Permit No. 756-77 Issued 6/20/77
date

Description of Use Accessory Building

RESIDENTIAL PLAN CORRECTION SHEET

ADDENDUM to Permit No. 756-77
 Owner D. SMALL
 Location 1052 WILLARD ST

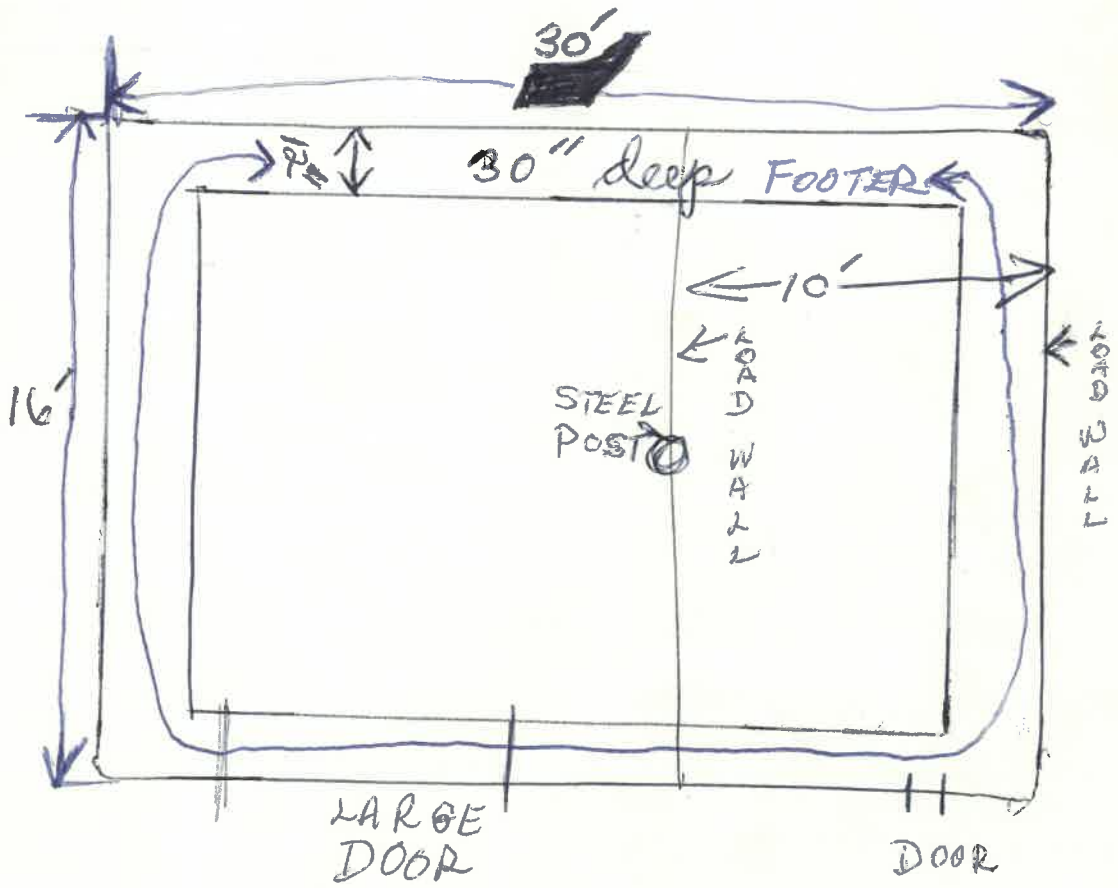
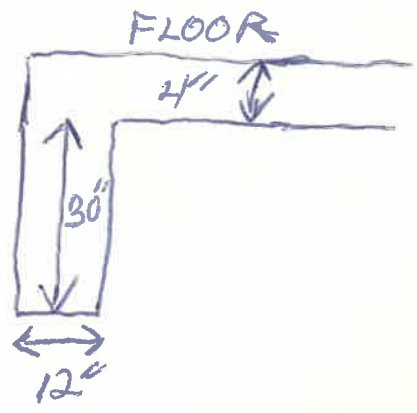
GENERAL	
<input type="checkbox"/> Provide 1 approved smoke detector.	<input checked="" type="checkbox"/> Show size of members supporting porch roof.
<input type="checkbox"/> Provide 1 hour fire wall and/or ceiling between garage and dwelling.	<input type="checkbox"/> Provide double top plate.
<input type="checkbox"/> Provide (Class B) 1 hour fire rated door from garage to dwelling.	<input type="checkbox"/> Provide design data for pre-fab. wood truss/members.
<input type="checkbox"/> Submit fully dimensioned plot plan.	<input type="checkbox"/> Ceiling joists undersized in.....
<input type="checkbox"/> Provide 1-3'0" x 6'8" exit door.	<input checked="" type="checkbox"/> Roof rafters undersized in <u>SEE BELOW</u>
<input type="checkbox"/> Provide min. 22" x 30" attic access.	PLUMBING AND MECHANICAL:
<input type="checkbox"/> Provide min. 18" x 24" crawl space access opening.	<input type="checkbox"/> Terminate all exhaust systems to outside air.

ADDITIONAL CORRECTIONS: PROVIDE INFORMATION ON ROOF RAFTERS, LOAD WALL & STEEL POST PRIOR TO INSTALLATION.
